F27 Doc 404106652

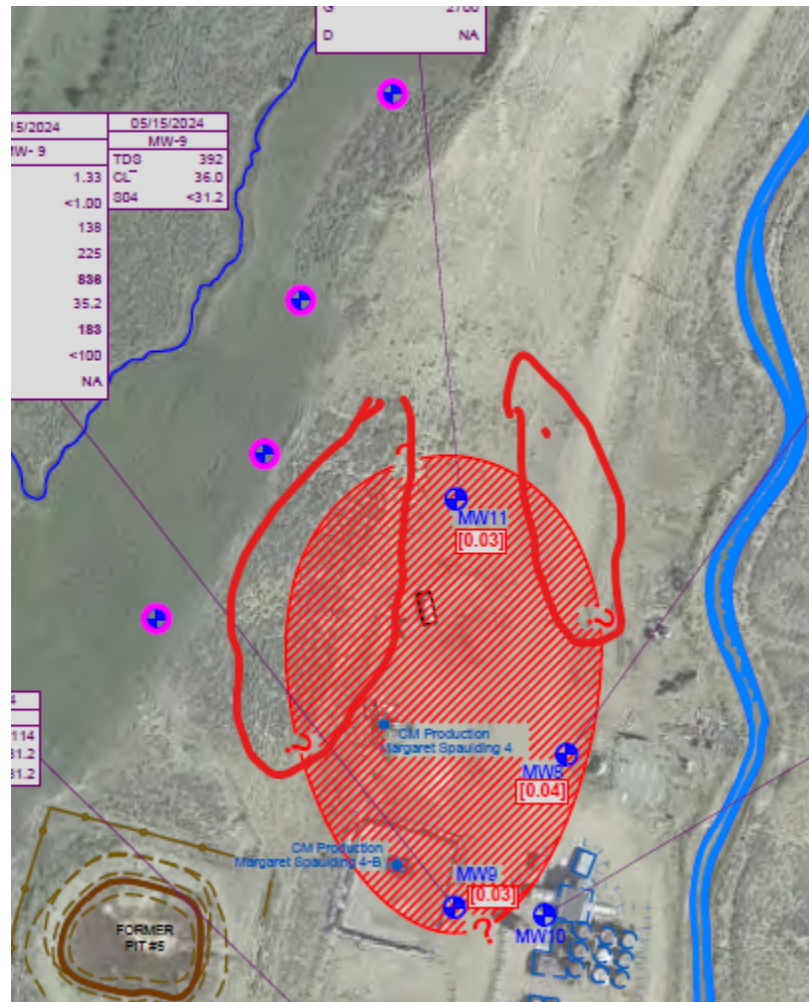
- LNAPL was previously observed at MW-E, which is located near the center of the remaining treater overflow pit on the site. The recent samples from MW-E were not reported to be impacted with significant levels of dissolved hydrocarbons.
  - Historical free phase HC present
  - Targeted remedial efforts at the Treater Overflow Pit (Pit Facility ID 115241)
- What monitoring well(s) is/are considered for background? (MW-5 and MW-6)?
- Figures 8 and 9 Proposed MWs
  - Consider advancing soil borings in proximity of the red outlined area and place MWs based on soil boring data.

- 
- Former Pits 4 (Pit Facility 112268) and 5 (Pit Facility 112269) have not delineated. Delineation of and remediation of impacts shall be completed.
-
